Docket Item # 6 and #7
BAR CASE #2005-0234
BAR CASE #2005-0235

BAR Meeting
November 2, 2005

ISSUE: Addition, New Garage, and Alterations & Waiver of
Rooftop HVAC Screening Requirement

LOCATION: 607 South Pitt Street

Figure 1 Proposed east elevation

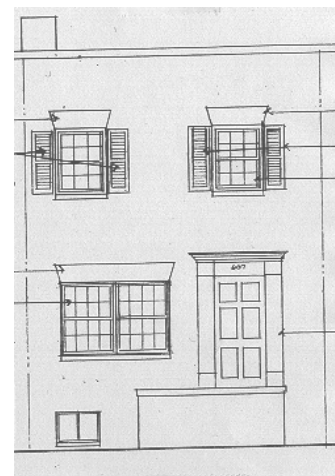
The current windows will be replaced on the front facade. The existing windows do not appear to be original and appear to be replacement windows. The drawings submitted by the Petitioner state that the new windows will be wood, double-glazed, simulated divided light with spacer bar, 7/8" muntin profile, eight-over-eight light configuration on the first floor, and six-over-six light configuration on the second floor, with the windows manufactured

by Kolbe and Kolbe. However, Staff expressed concern to the Petitioner and to the Petitioner's architect over the use of double-glazed and simulated divided light instead of single-glazed and true divided light. The Petitioner has verbally agreed to use for the front facade replacement windows, wood, double-hung, single glazed, true divided light windows, with the appropriate light configuration, manufactured by Kolbe and Kolbe. The Petitioner will also use wood trim around the front door to replace the deteriorated wood door surround.

Staff recommends approval with the understanding that wood, double-hung, single-glazed, true divided light windows are used as replacement windows on the front facade and the following conditions:

Figure 2 Proposed rear elevation

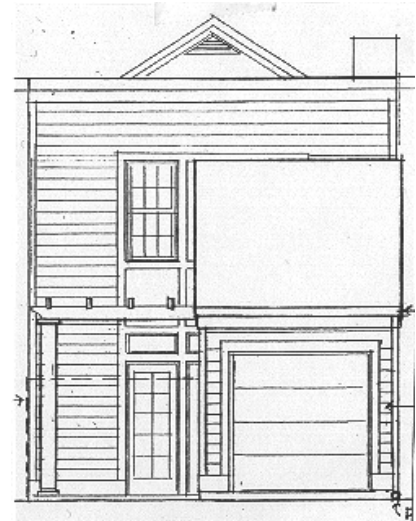
A two-story, rear addition is proposed for this property, with a depth of 20'6" and a width of 18'. The rear addition has a foot print of 369 square feet. The existing house has a footprint of 581.4 square feet. The proposed addition will result in the demolition of the existing rear wall. The new addition will be clad in smooth Hardi-plank with a 6" reveal and painted grey. All trim will be white. The side walls will be 8" CMU walls with cement parge to provide necessary firewalls. Three windows on the second floor of the addition will be wood, double-hung, simulated divided light with a 7/8" muntin profile, with a six-over-six light configuration, and manufactured by Kolbe and Kolbe. On the first floor, three swing-in, French-style doors, with transoms will provide access to the rear courtyard area. The doors are also manufactured by Kolbe and Kolbe. The addition will have through the wall aluminum scuppers, with downspouts attached to the exterior corner trim. A gabled skylight will be located on the roof of the new addition, largely screened from public view by the parapet of the roof. A fiberglass pergola will be attached to the new addition, supported by 10" round Doric columns.

Figure 3 North elevation of garage

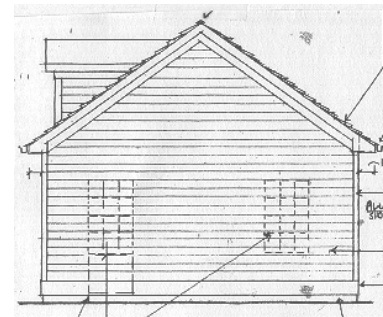
A new one car garage will be constructed within the existing rear courtyard area. The proposed garage will be 205 square feet. Originally, the Petitioner had proposed a two-bay garage, with a large dormer window on both the alley and courtyard elevations. The open-space requirements would not allow the two-bay garage as proposed. The Petitioner revised the proposed garage, reducing the size to one-bay and eliminated the dormer facing the alley, while keeping the dormer facing the main house, to provide light and access to storage within the garage. The dormer will not be largely visible from the public-right-of-way of the alley. The dormer's window will be a six-over-six, double-hung, window by Kolbe and Kolbe. The proposed garage will be sided with smooth Hardi-plank siding with a 6" reveal and the gable roof will have shingles. White aluminum gutters will be installed at the fascia, above the garage door openings. The Petitioner is proposing either two windows on the north wall, facing the open space, to match windows on the front facade or one window and one six- panel wood door. Staff would support either option. Wood, overhead garage doors are

proposed, for both the west and east elevations of the new garage.
